Planning Commission Staff Report

June 10, 2015

- SUBJECT:** P15-0001
- APPLICANT:** Eric Shephard
- PROPERTY OWNERS:** Mahadevan and Jaanaki Rajagopalan
- PURPOSE:** Application for Design Review approval to construct an approximately 4,292-square-foot, two-story custom home on an approximately 61,097-square-foot parcel

- LOCATION:** 1 Winding Oaks Drive (Lot 1)
- GENERAL PLAN:** Low Density Residential and Open Space-Public Health and Safety
- SPECIFIC PLAN:** Vineyard Avenue Corridor

Figure 3: Proposed Elevations

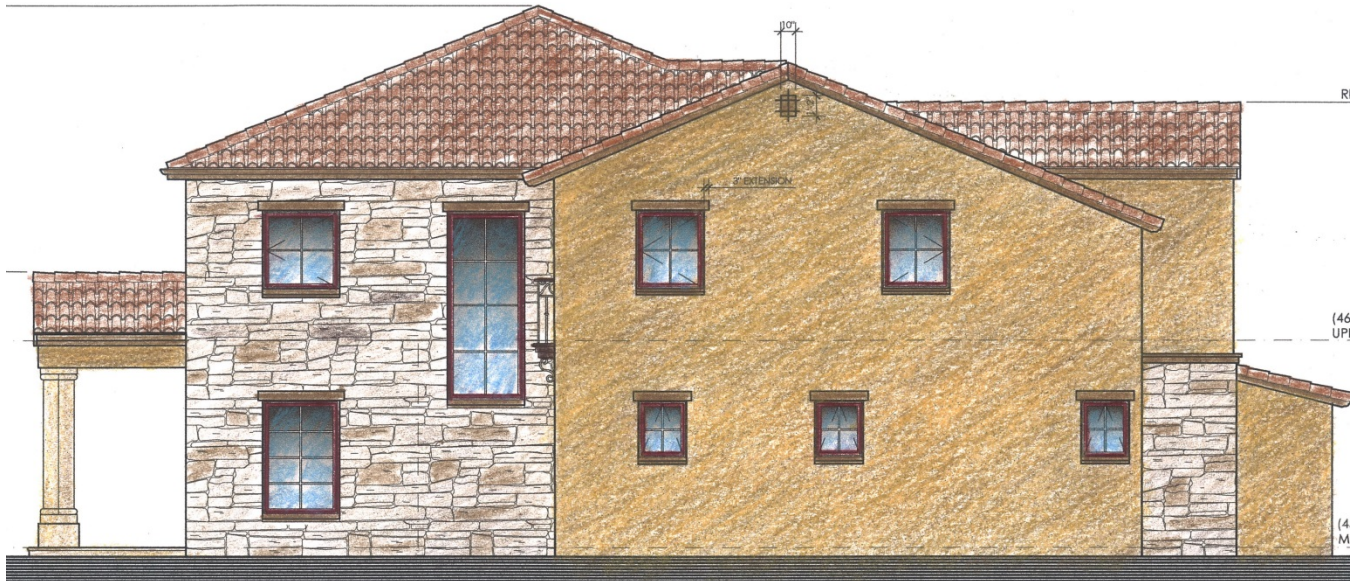
The proposed home is a two-story structure with articulated wall lines that provide a break in the massing of the home and promote visual interest. The roof lines are varied to mitigate the massing of the structure and the majority of the front façade incorporates stone veneer and smooth stucco.

As proposed, the exterior walls of the house will be articulated and, therefore, the massing of the building will be compatible with others in the neighborhood. The use of stone treatments, wall articulation and detailing will provide an attractive home for the neighborhood. The projecting front entry porch element and porte cochere add architectural interest and the home design incorporates high quality materials and elements. The front entry and garage doors are nicely detailed and are compatible with the design of the proposed home. The cementitious stone window and door trim are also compatible with the proposed design. In general, the architectural design and finish materials/colors are generally consistent in their interpretation of the required Tuscan Farmhouse architectural style. Figure 3 shows the proposed elevations.
